Technical Service Bulletin						
Date Issued			Model(s) Affected		TSB#	
10/20/2006	Prior to 6/17/05		Spartan Chassis with CAT C9 Engines		292	
	Brand					Гуре
All	American Star Dutch Star		Mountain Aire Kountry Aire		All □ FW□	ТТ 🗆 СА 🗖
_	Kountry Star		Essex		D P ■	DB \square
Scottsdale	Northern Star		London Aire			
☐ Air Conditioning &	k Heating	I	☐ Electrical Comp	onents		
☐ Appliances & Acce	essories	I	☐ Exterior Compo	onents		
☐ Cabinets & Furniti	ıre	ı	☐ Interior Compo	nents		
■ Chassis Componer	nts	ļ	☐ Plumbing & Bat	th Compo	nents	
☐ Construction Com	ponents	I	☐ Windows, Awni	ngs, Vent	s, & Doo	rs
	Descr	ription of	Problem			
C9 ENGINE OIL DIP	STICK:					
Potential for Incorrect Engine Oil Level and for Engine Oil Leak The dipstick is not calibrated correctly and the dipstick tube may be exposed to excessively high temperatures in which the tube material could melt.						
			Solution			
	rccom	menaca	Joidholl

RE: Engine Oil Dipstick Tube and Dipstick Tube Campaign Service Bulletin

SUBJECT: C9 Engine Oil Dipstick

APPLIES TO: All Spartan Chassis Models Equipped with a Caterpillar C9 Engine,

DIPSTICK TUBE ATTACHMENT AT ENGINE FIG. 3-1

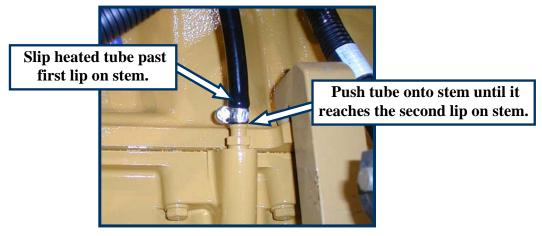
- 4. Refer to FIG. 3-1. Disconnect tube from engine by loosening the worm clamp where the tube attaches to the stem on the engine. Properly dispose of tube and dipstick. Retain clamp.
- 5. Remove dipstick from the new dipstick tube and set aside.

6. With a torch, heat new tube (DO NOT OVERHEAT) and push it onto the dipstick tube stem from which the old tube was removed. Tighten clamp.

NOTE: The tube must be inserted onto the stem past the first lip and slid down to the second lip as shown.

CLIP INSTALLATION FIG. 4-1

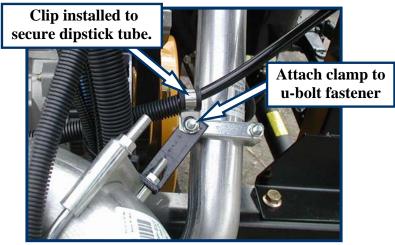
- 8. Refer to FIG. 4-1. Secure dipstick tube by installing the rubber covered loop clamp at the U-bolt attachment closest to the place where the loom ends on the dipstick tube. Torque to 10 FT. LBS.
- 9. Install dipstick and adjust oil level as necessary.
